DCE MEMORANDUM NO: 10-09
(FHWA Approved: 4-30-09)

SUBJECT: CLARIFICATION OF SPECIFICATION 455-16.2 and 455-20 (d)

Drilled shaft with oversized hole at the top and/or extra depth at the bottom, resulting from contractor's means and methods.

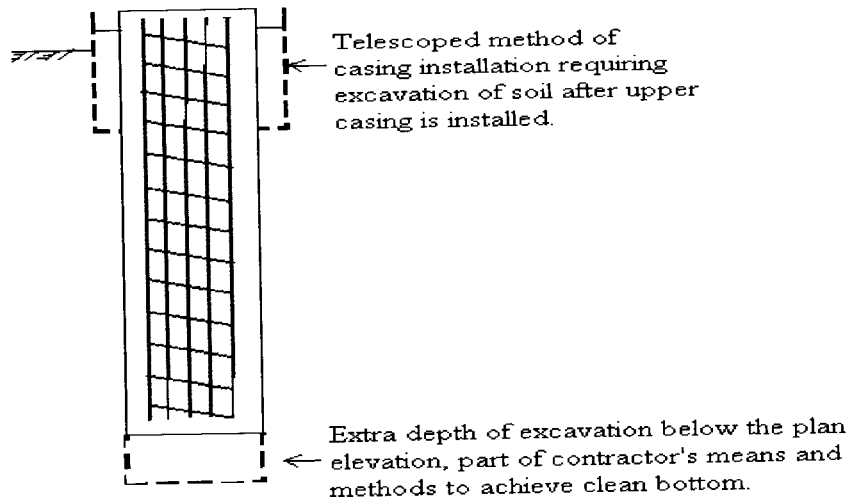
This memo is issued to clarify Specification 455-20(d) regarding the required concrete cover during the installation of drilled shafts to support mast arms, cantilever signs, overhead truss signs, high mast light poles or other miscellaneous structures, and provide an exception to Specification 455-16.2 Splicing Cage for these shafts as described in the situations shown in the figure below.

1. Specification 455-15.8.3 requires providing a temporary surface casing during the installation of drilled shafts for miscellaneous structures. During this process, the contractor may elect to provide a casing, larger in diameter than shown in the plans. However, this method of excavation results in an oversized diameter of the shaft for the length of the casing. The O.D. of the installed casing shall not be greater than 24 inches larger than the diameter of the cage. Soil removed due to the oversized excavation, must be filled with the drilled shaft concrete at no additional expense to the department. Meet the reinforcement cover requirements per Specification 455-20(d).

2. If the excavation is over excavated below the required tip elevation, to facilitate meeting the shaft cleanliness requirements of Specification 455-15.11.4.1 or another reason related to the contractor's means and methods, reinforcement bars need not be spliced in accordance with Specification 455-16.2 if the contractor can maintain the top elevation of the cage as given in the plans.

The contractor must take all the necessary precautions during the placement of the reinforcement cage through the oversized hole to meet the construction tolerances per Specification 455-20 and 455-21. The Drilled Shaft Installation Plan 455-15.1.2 (7) should indicate the details of shaft reinforcement, including methods to ensure centering/required cover, cage integrity during placement, placement procedures, and cage support.

However, if maintaining the correct top elevation of the reinforcement is not possible, or differing site conditions require the need for additional structural length as determined by the District Geo-technical Engineer, the contractor must splice the reinforcement bars per Specifications 455-16.2 and provide concrete spacers per specification 455-16.3.
